# **ADDENDUM TO AN ENVIRONMENTAL IMPACT REPORT BUTTERFIELD BOULEVARD AND CHANNEL EXTENSION PROJECT**

**August 2005**

FIGURE 2

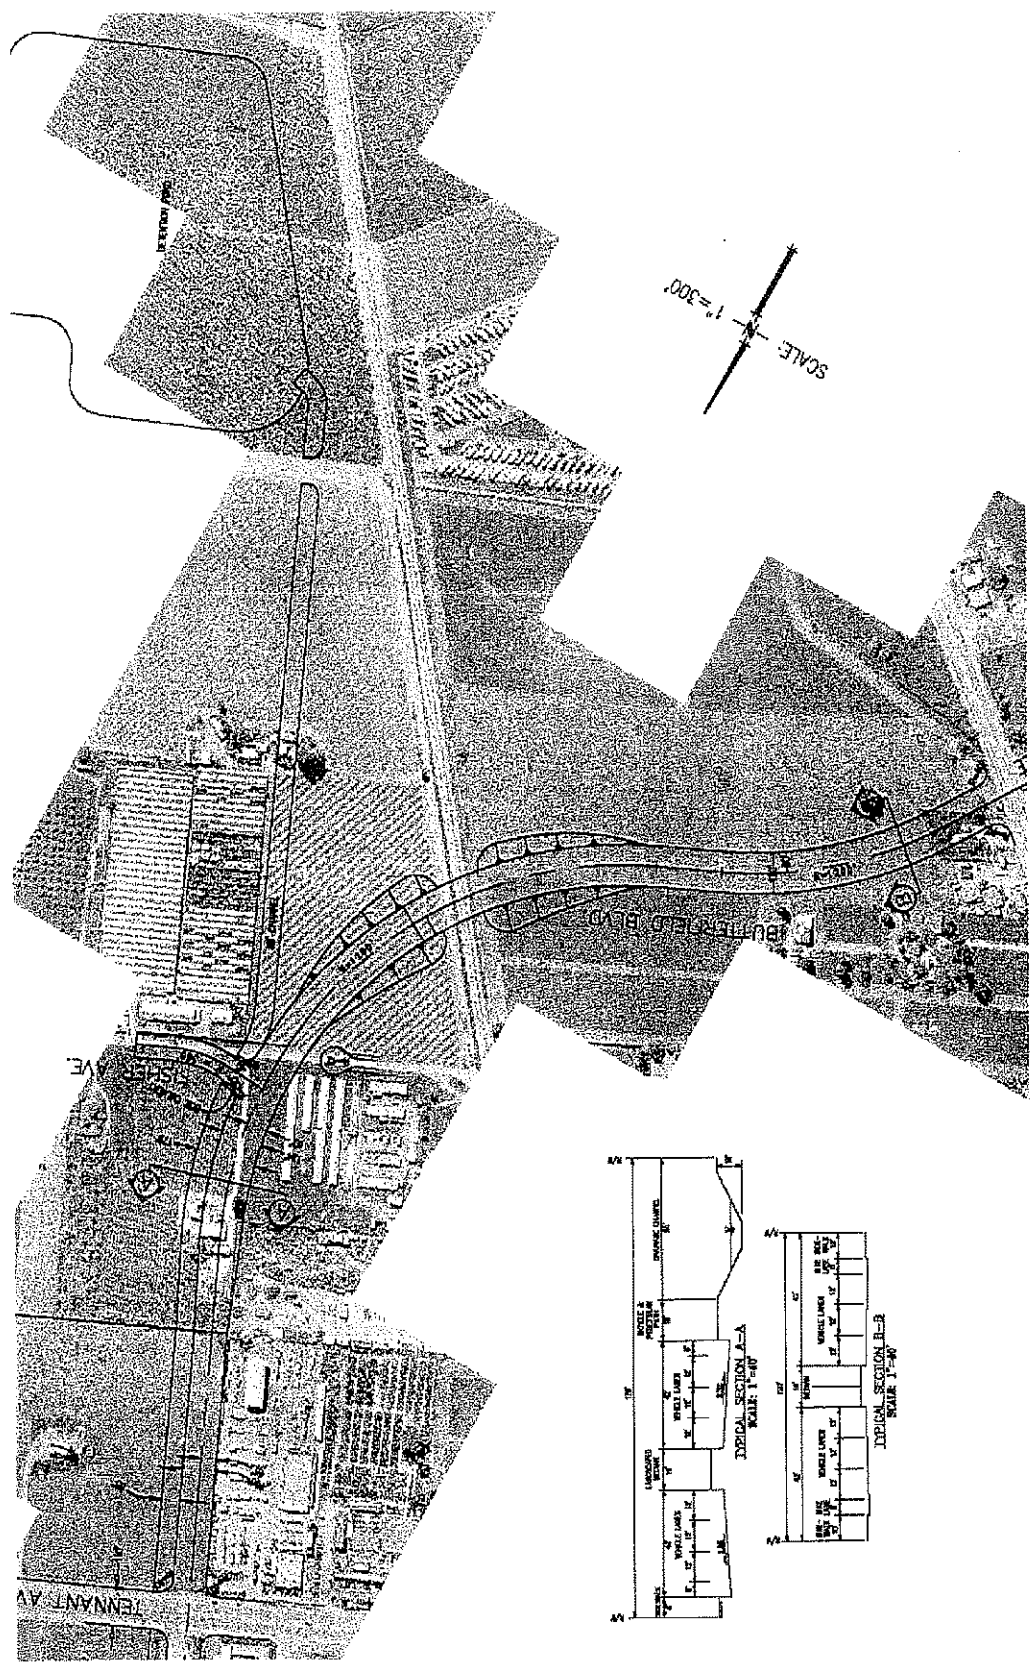
travel lanes on the Watsonville Road extension is increased from two lanes to three lanes in each direction; 2) the Watsonville Road at-grade crossing of the existing Union Pacific Railroad (UPRR) line is replaced with an overpass; and 3) the alignment of Watsonville Road is slightly modified to create a continuous connection with Butterfield Boulevard. Site plans of the project evaluated in the 1992 FEIR and the currently proposed project are shown on Figures 1 and 2, respectively.

The project proposes three vehicle travel lanes in each direction on the Watsonville Road extension. Compared to the project evaluated in the 1992 FEIR, this is an increase of one travel lane in each direction and will require an additional 28 feet of right-of-way, increasing the typical amount of right-of-way required for the Watsonville Road extension from 92 feet to 120 feet.

The Watsonville Road extension to Butterfield Boulevard will cross the existing UPRR line. The project proposes an overpass crossing of the UPRR line instead of an at-grade crossing, which was previously proposed and evaluated in the 1992 FEIR. The roadway extension will remain at-grade until approximately 525 feet before and after the UPRR line. The maximum height of the railroad overpass will be 30 feet. The construction of the overpass will require additional right-of-way compared to the previously evaluated at-grade crossing in order to construct the foundation to support the elevated roadway. The right-of-way width required to construct the overpass will be approximately 240 feet.

Compared to the approved project, the proposed connection of Butterfield Boulevard and Watsonville Road will be continuous instead of connecting at a T intersection. The proposed Watsonville Road/Butterfield Boulevard alignment is shown on Figure 2.
